Appendix R

Comments and Responses on the 2014 Draft

Comments and Responses on the 2014 Draft EIS/EIR

Long-Term Water Transfers
Final EIS/EIR

Figure R-2.
Extent of Tuscan and Tehama Formations with respect to groundwater substitution pumping under Proposed Action

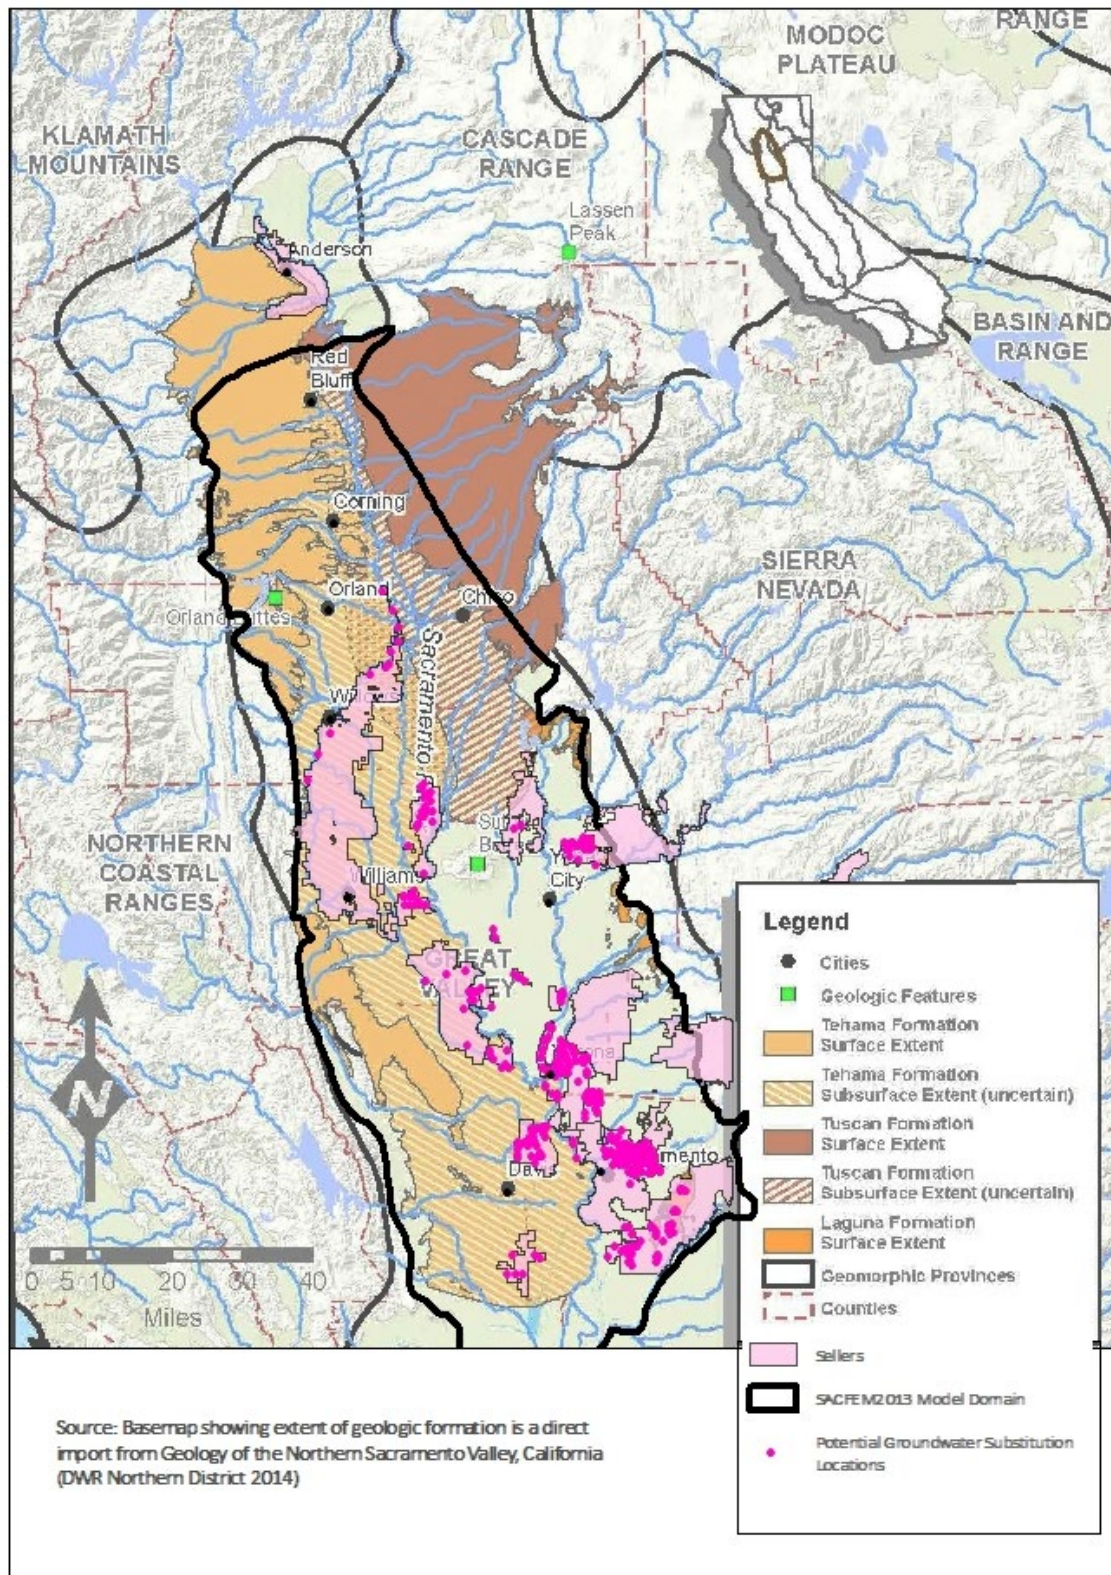
Concerns regarding pumping in the Tuscan Formation

Commenters expressed concerns that transfer-related pumping would be concentrated in the Tuscan Formation. As shown in Figure R-2, groundwater substitution pumping associated with the range of potential activities analyzed under the Proposed Action would occur primarily outside the Tuscan formation, either from the Tehama Formation or other formations not identified in Figure R-2. Some of the groundwater substitution pumping wells for Glenn-Colusa Irrigation District, Reclamation District 1004, and Butte Water District lie within (or near) the potentially disputed Tuscan and Tehama subsurface formations. Pumping from these wells will be closely monitored through the implementation of Mitigation Measure GW-1 to avoid potentially adverse effects. Refer to Common Response 6 for a discussion of revisions to Mitigation Measure GW-1 in response to public comments.

Figure R-4.
Spring 2014 Groundwater Elevation Measurements at Well 17N03E16N001M

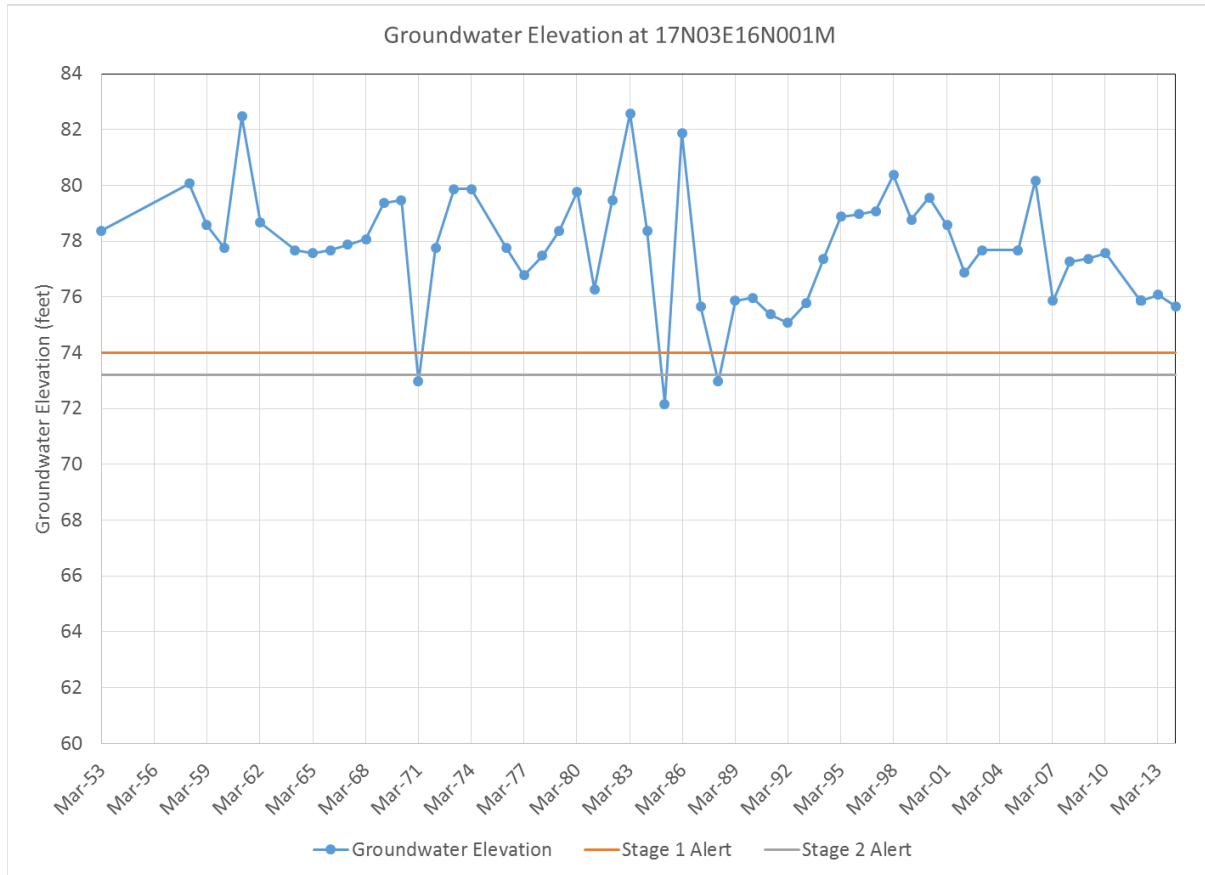
See Common Response 4. The statement "wells in the basin have remained steady, declining moderately during extended droughts and recovering to pre-drought levels after subsequent wet periods" is based on past hydrologic conditions. At well 21N03W33A004M (DWR 2014a) groundwater levels recovered after declines noticed during drought conditions between 1975 and 1977. Current drought conditions have caused groundwater levels in some regions to decrease below historic lows noticed from 1900 through 1998. Additional data has been added to the Groundwater Resources section to present data for current dry conditions.

The Lead Agencies acknowledge that basin management objectives (BMO) alerts have been reached in some parts of Butte County. As a clarification, Butte Water District is the only seller in Butte County under the Proposed Action, and it has not proposed groundwater substitution-related pumping within Butte County. The Lead Agencies have reviewed the 2013 Groundwater Status Report (http://www.buttecounty.net/Portals/26/Reports/Butte_14_BMO.pdf) and noted groundwater elevation at well 17N03E16N001M during the fall 2013 monitoring falling below the Fall BMO Stage 1 alert by 0.3 feet, and the fall 2014 measurement falling below the Fall BMO Stage 2 alert by 0.7 feet (https://www.buttecounty.net/wrcdocs/Programs/Monitoring/GWLevels/2014/2014_Fall_BMO_Data.pdf). See Figure R-4 for spring 2014 measurements showing groundwater elevations approximately 2 feet above BMO alert 1 level. This is indicative of seasonal fluctuations in groundwater level with recovery in the post transfer period. The Lead Agencies acknowledge the long-term declining trend noticed between 1976-77 and 1987-92 and, more recently, from 2010 to the present. See Common Response 6.

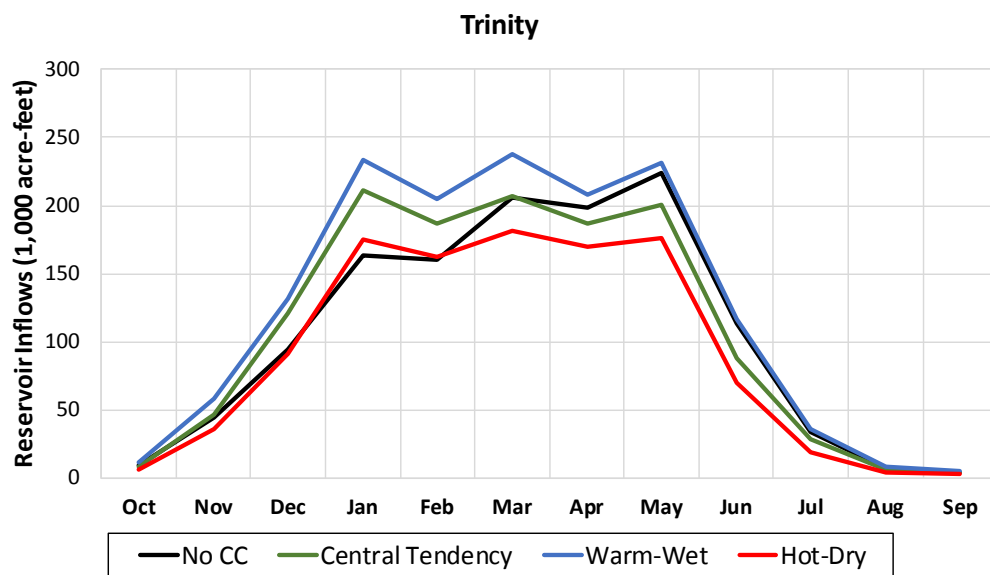
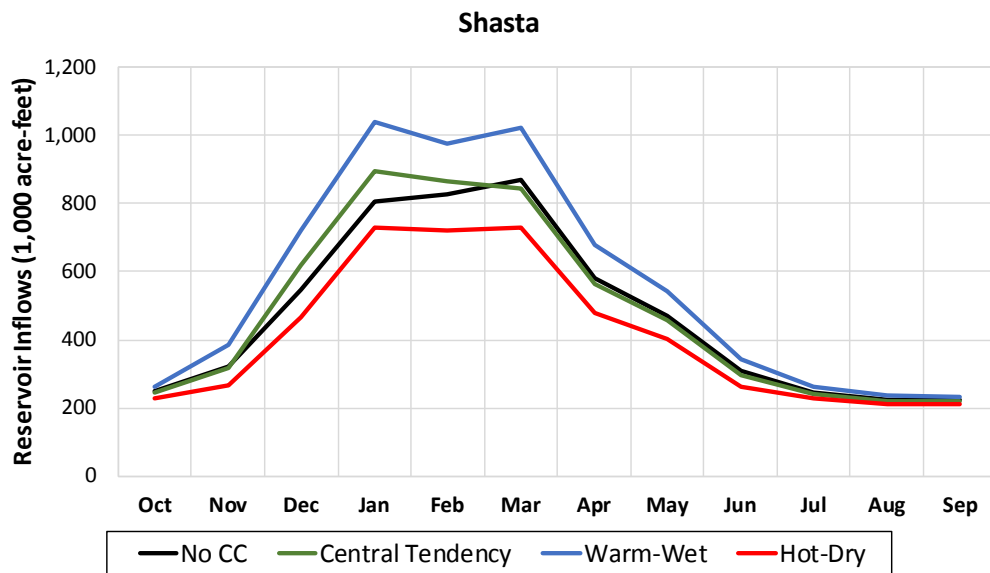
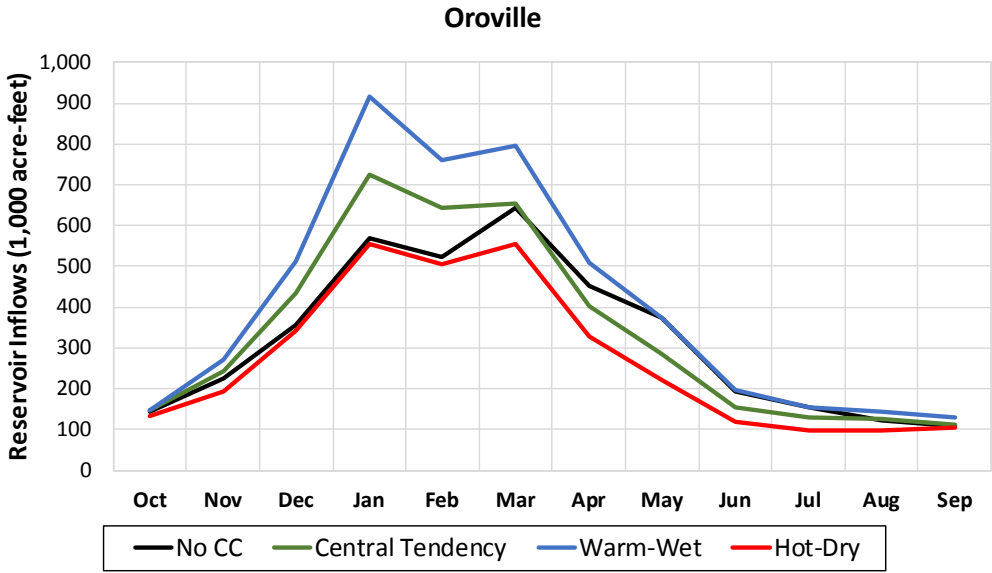
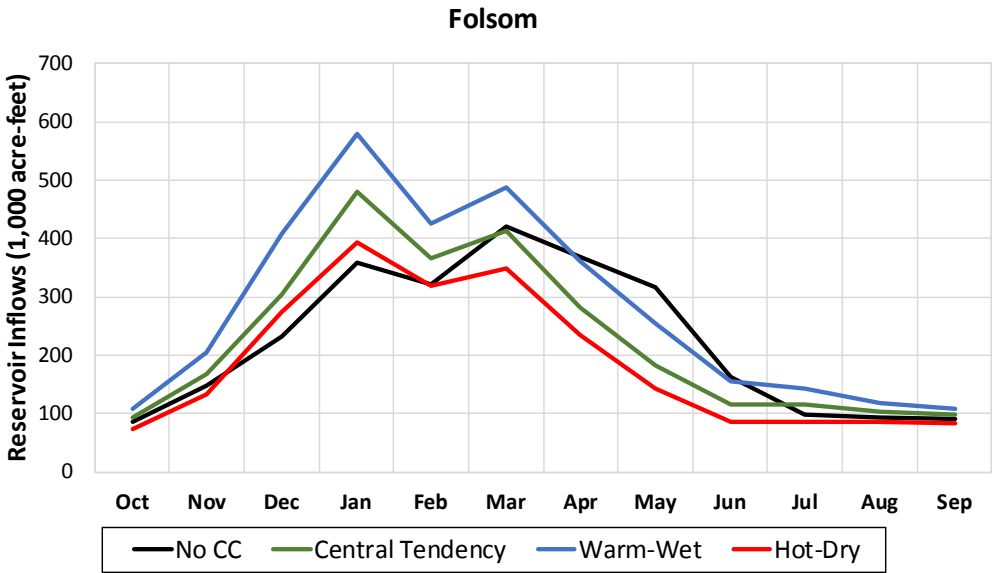
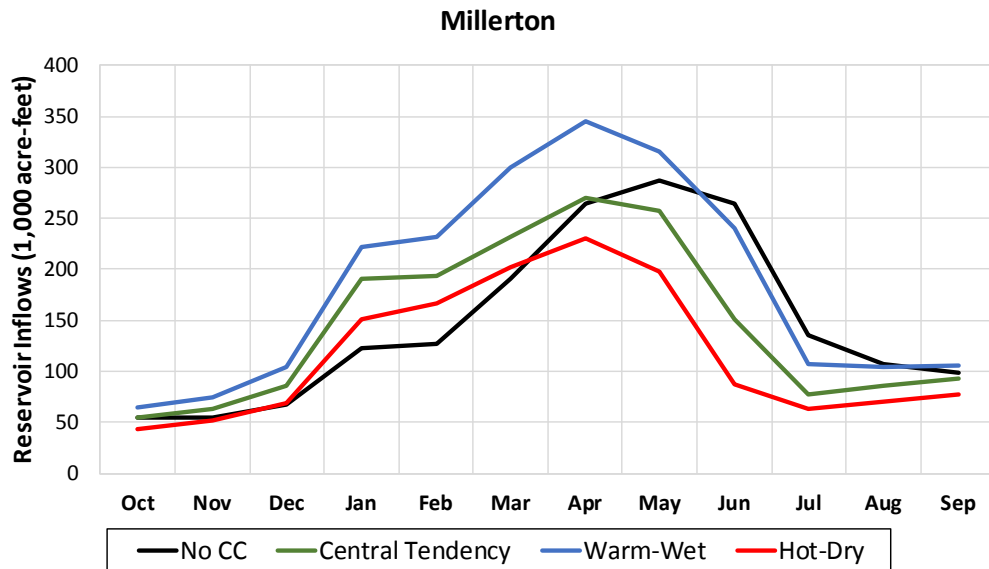
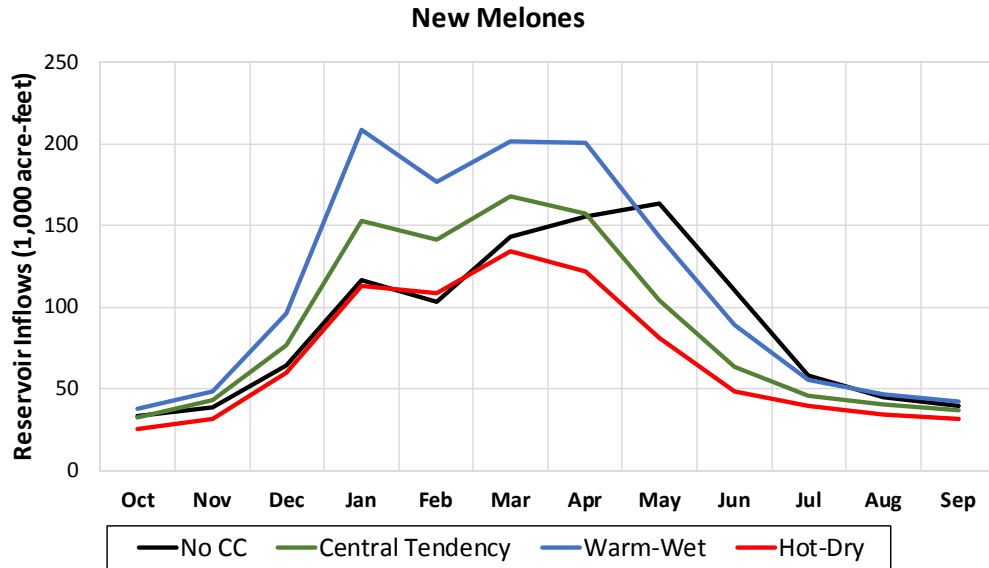
Specifically, the RDEIR/SDEIS appears to rely on the "CalLite-CV model" that provides various climate change scenarios such as the "Central Tendency," "Hot-Dry" and "Warm-Wet" scenarios." (RDEIR/SDEIS, p. J-6.) What the RDEIR/SDEIS and even its technical report

(Appendix J) fail to explain, however, is whether the CalLite-CV model incorporates the reduced snow water equivalent and temporal inflow shifts relied upon by the District Court to invalidate the original EIS/R. While Appendix J generally discusses these changes in runoff and snowpack, there is no suggestion that the CalLite-CV model actually incorporates them. (RDEIR/SDEIS p. J-5.) In fact, the RDEIR/SDEIS's technical study suggests that it does not by stating, "[I]t remains difficult to attribute observed changes in hydroclimate to historical human influences or anthropogenic forcings." (*Ibid.*) Further, the RDEIR/SDEIS fails to explain the amount of carbon emissions underlying the CalLite-CV model. This is relevant because the District Court in *AquAlliance* specifically disagreed with BOR's claim that the "A2" emission scenario was a "worst case" scenario under NEPA. (*AquAlliance*, supra, 287 F. Supp. 3d at 1029.)

- It is unclear whether the CalLite-CV model incorporates reduced snow water equivalent and temporal inflow shifts.
- The RDEIR/SDEIS fails to explain the amount of carbon emissions underlying the CalLite-CV model.

The following figures illustrate the simulated, monthly average inflow to major CVP and SWP reservoirs under the three representative future climate scenarios and a simulated no climate change scenario. These simulated inflows were inputs to the CalLite-CV model.

Comparisons of the no climate change (No CC) inflow with the three representative future climate scenarios illustrate the temporal shift in inflow to the major CVP and SWP reservoirs. The Hot-Dry climate scenario shows reduced inflow, as compared to the no climate change scenario, in June, July, and August, at all reservoirs.

The RDEIR/SDEIS's technical study does not suggest that the CalLite-CV model fails to incorporate reduced snow water equivalent or temporal shifts in inflow, as the commenter states. The commenter quotes a section of Appendix J of the RDEIR/SDEIS (renamed to Appendix K) that simply states it is difficult to attribute changes in hydroclimate to a particular cause.

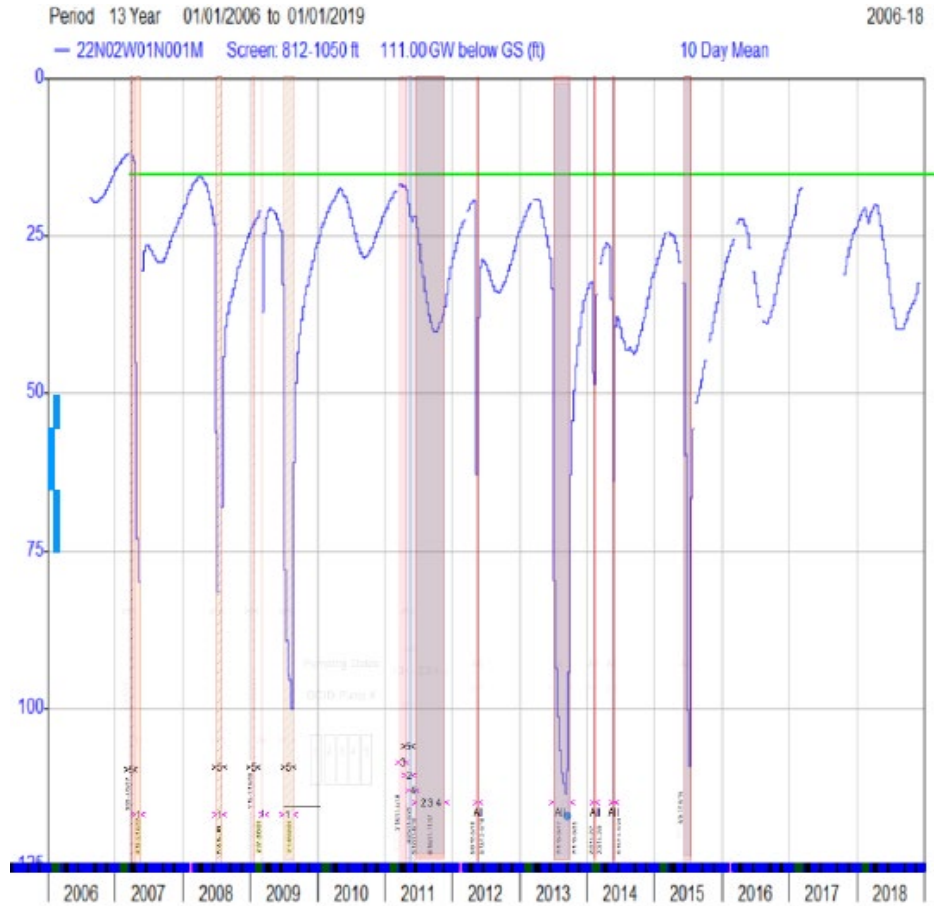
DWR/Glenn County monitoring wells 22N02W01N, 22N01W29N, 21N02W01F, and GC 36A show that GCID pumping a total of 20,000 acre feet, over an eight year period, has caused unacceptable impacts to the area.

Prior to 2007, the aquifers were able to fully recharge with an average rainfall year.

GCID began large scale groundwater pumping in 2007 and continued until July 2015. Although this pumping was ostensibly limited to the 950'---1200' deep (Tuscan) aquifer, the three overlying aquifer strata at ±600', 300' and 100' have all been affected, and remain compromised.

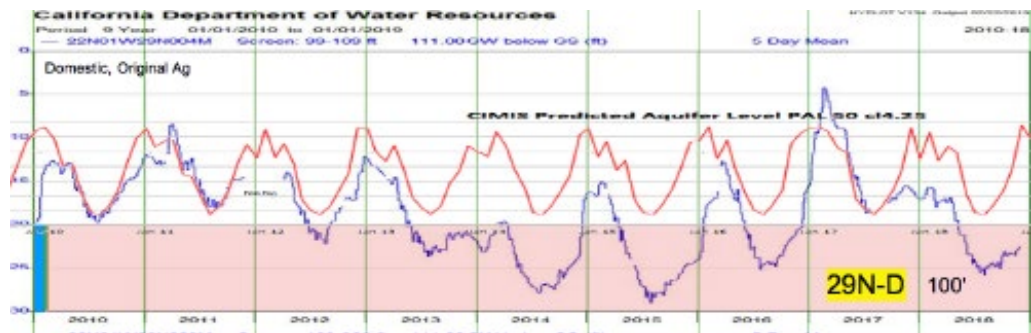
- 1
- 2 Scale from Pump 1 to 5 is approx. 10 miles.
- 3 Nearly four years after the pumping ended, the 1000'---1200' aquifer still has not recovered to
- 4 95% recharge levels.

- 1
- 2 The Predicted Aquifer Level (PAL curve in red) uses evapotranspiration and rainfall data from
- 3 CIMIS #12 in Durham to predict where the aquifer would be, without the influence of GCID
- 4 transfer pumping.

- 5
- 6 When these pumps are turned on, an extremely rapid draw down occurs over a few hours. It is
- 7 equivalent to a pressure drop of over 10,000 psf . The rapid loss of this pressure is a significant
- 8 factor in a new situation for our area –overdraft pumping caused subsidence. New cracks in two
- 9 of our brick homes began to appear after 2007. Even though both are built on heavy foundations
- 10 and were previously unbroken the gaps are getting more serious with time. This alone has
- 11 seriously devalued our historic brick and beam ranch house.
